Continuous SClk Proposal

Colin Whitby-Stevens
ST

P1394a Ft Lauderdale December 1997

Figure 5-3 - PHY-Link reset timing

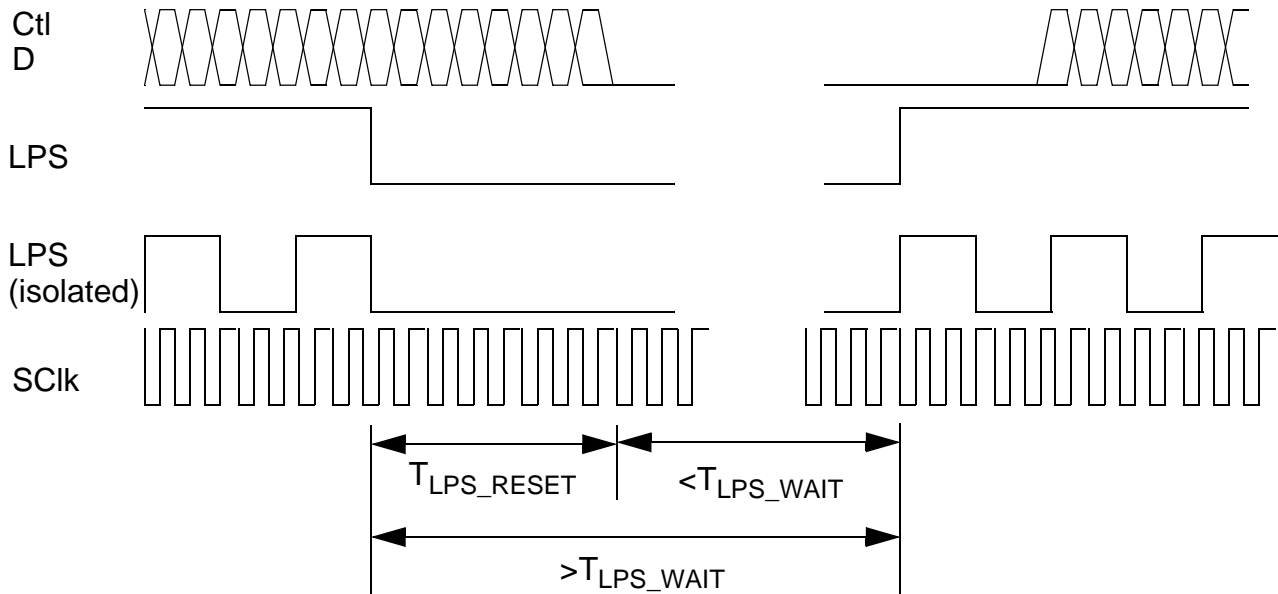
Modify Figure 5-3 to show SClk present during PHY/Link interface reset, and to show min/max

timings (T_{LPS_WAIT} starting from when LPS is deasserted).

Figure 5-nn - PHY-Link disable timing

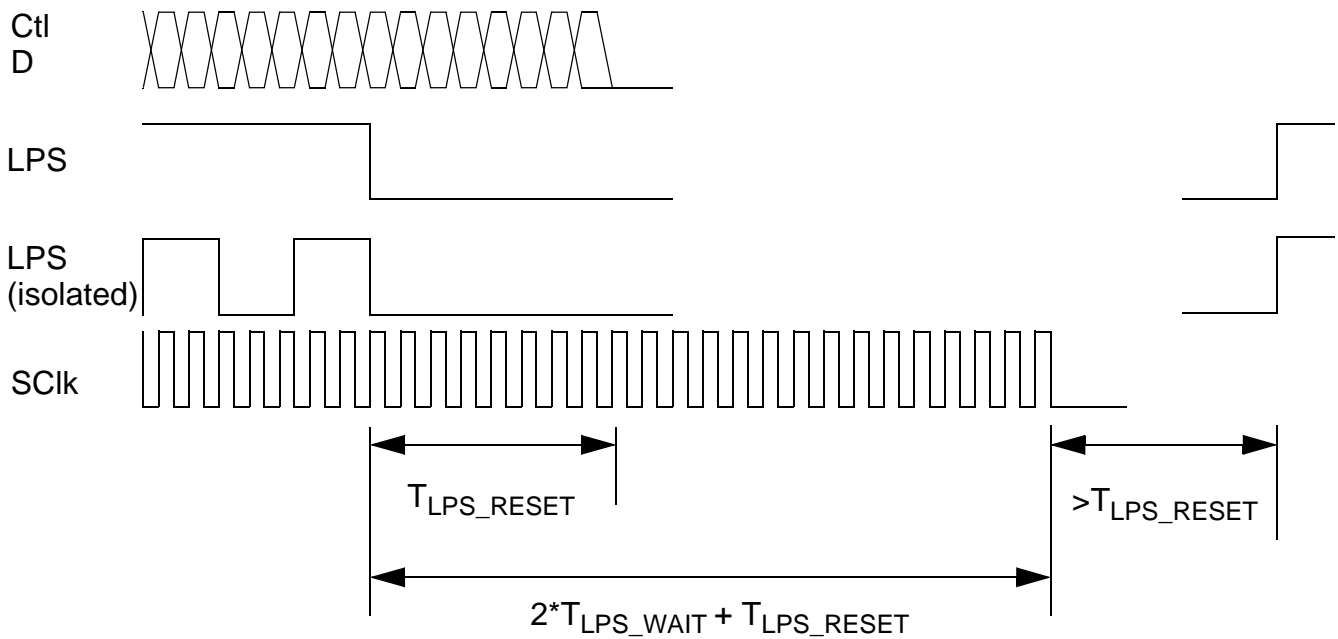
Add a new figure to show PHY-Link disable timing
